Tamanna Tex Ltd. (25242)

Plot No A 34, BSCIC Kanchpur, Sonargon, Narayanganj
(23.698774, 90.527735)
2nd February 2021

Buildings Information

Discrepancies in as built drawing with on site condition

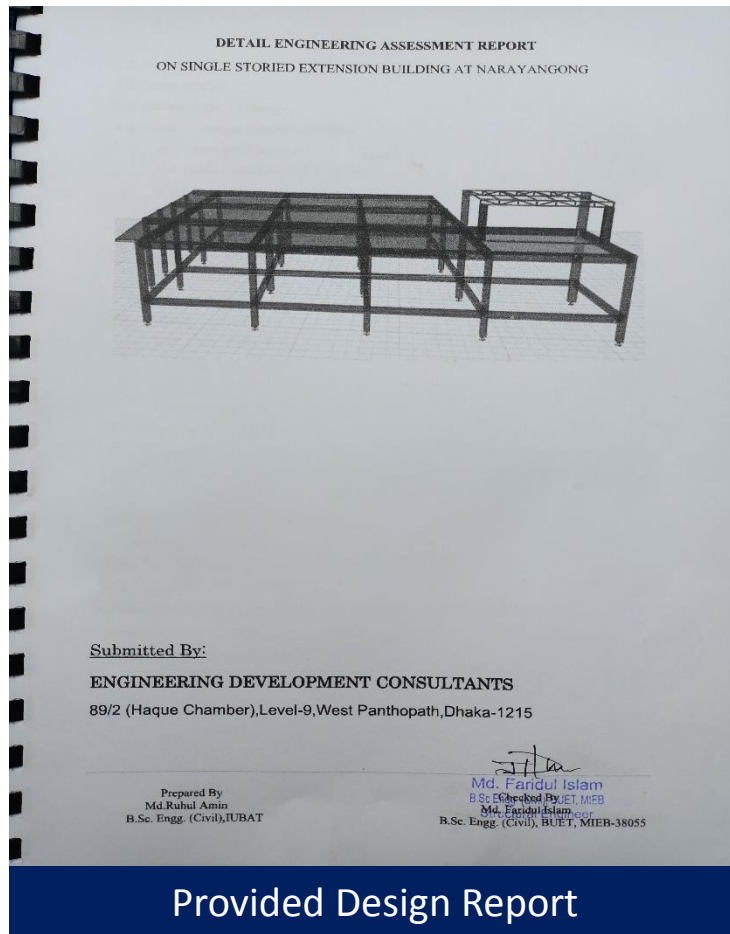
Column dimension shown in provided drawing

Column dimension measured
250mmX375mm

Dimension of column C-1 at grid E-2 was found 250mmX375mm instead of 250mmX450mm. Factory engineer is required to update the as-built drawing as per onsite condition.

Recommendation in proposed drawing not implemented

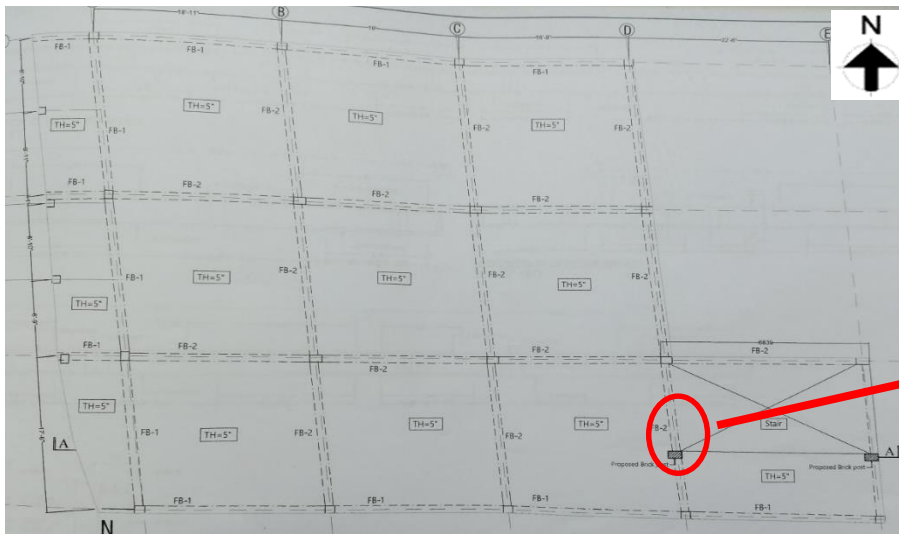
Brick post was missing at this location

A brick post was proposed in provided drawing which was not installed. Also, the roof truss of stair core was not replaced as per proposed drawings. Factory engineer is required to check the proposed scheme and implement if required.

Proposed Truss of stair case

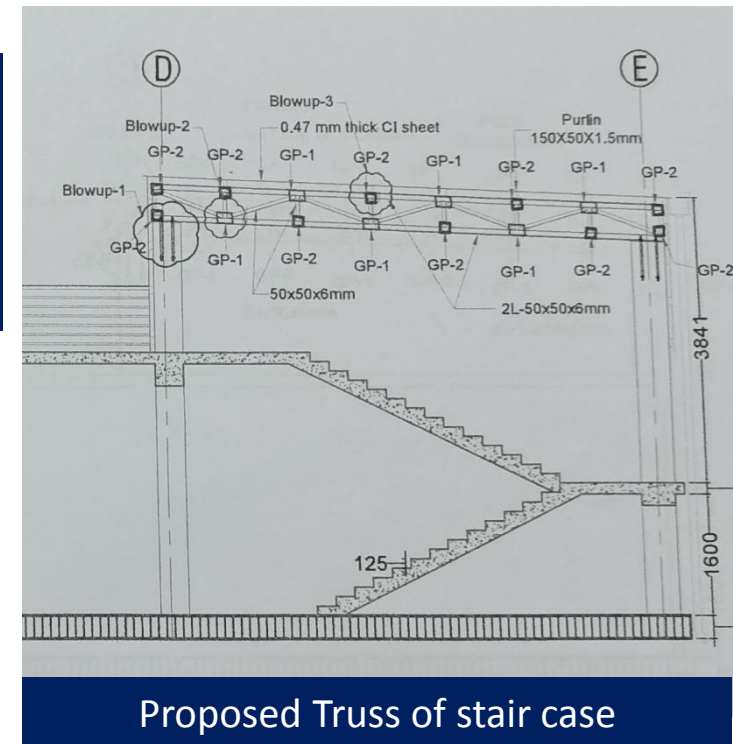
Existing truss at stair case
